**ARCHITECTURAL REVIEW COMMITTEE
STAFF REPORT
AGENDA ITEM NO. 1
June 29, 2006**

Request for an Architectural Review Permit for a new façade and signage at the Lunardi's Market at 100 Skycrest Center per Chapter 12.108 of the San Bruno Zoning Ordinance. Sutti Associates (Applicant) and Willow Green Associates (Owner). **(AR-06-002)**

100 Skycrest Center
019-281-010
AR 06-002

1 SITE PLAN
A1.0 1/8"=1'-0"

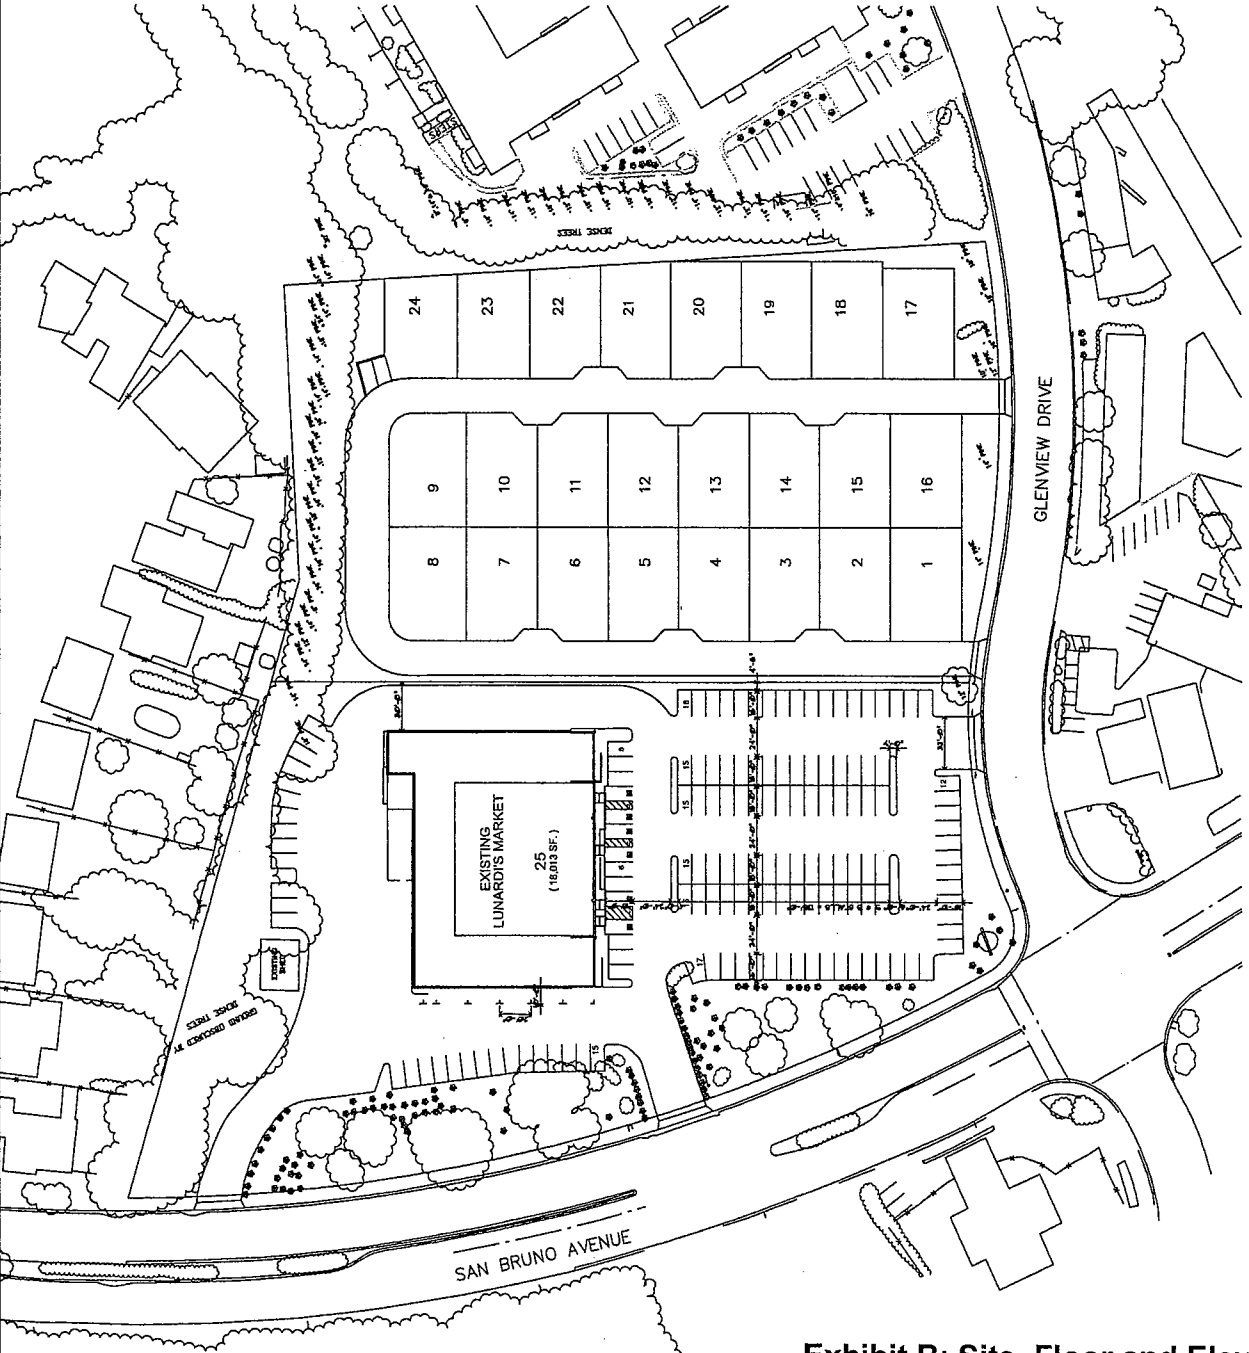
- Staff has some concern with the lack of landscaping and cart storage in the existing and proposed parking lot facility. With no existing "shopping cart corral", improperly stored carts have been windblown into parked vehicles and landscaping in the past. Furthermore, with the fairly expansive parking lot, no landscaping has been proposed as part of the exterior improvements to the building and site. Staff recommends that the applicant consider widening the end medians of the center parking lot stalls to include landscaping and a cart storage area to eliminate this problem. While the expansion of these end medians would most likely need to remove a parking space on the interior side (since the adjacent way is for two-way parking lot traffic), the current parking supply is more than adequate to allow for this. Furthermore, a new cart storage system could allow the applicant to provide for some of the landscaping design as suggested by City staff and peer review architect Larry Cannon.

Currently, no landscaping plan for the paved parking area has been proposed, despite staff's recommendations to the applicant. Therefore, as a condition of approval, staff is requesting the applicant work with City staff to develop a feasible landscaping plan for the paved parking area that will satisfy all interested parties. Street front landscaping consists of weather resistant trees, shrubbery and low-maintenance ground cover. Staff is currently researching the terms of a landscaping agreement negotiated with Skycrest Homes for potential uses on the subject property. Adjacent residential properties are sufficiently screened and the Skycrest Homes subdivision has proposed adequate landscaping on the shared property line between the development and Lunardi's Market, including tree

10. Prior to the issuance of a city building permit, applicant shall execute and record an installation and maintenance of landscaping agreement for (a) the installation of six planters, irrigation and plantings in the parking lot ("Planters"); (b) the design and installation of frontage landscaping on San Bruno Avenue and Glenview Drive ("Frontage Landscaping"); and (c) the maintenance of the Planters, Frontage Landscaping and irrigation systems. The agreement shall be in a form approved by the City Manager and City Attorney and shall run with the land and be binding upon successors in interest of the owner. The agreement shall include the following terms and conditions:

- i. All landscaping shall be properly maintained and comply with the City of San Bruno Water Efficient Landscape and Irrigation Guidelines.
 - ii. With respect to the Planters, they shall be installed concurrently with the construction of improvements to the grocery store. The applicant shall identify the species of plants and their location in the agreement. The six planting areas shall include four islands at the corners of the parking lot area and two islands in the center of the parking lot. The two center islands will replace two parking spaces and will also contain shopping cart corrals.
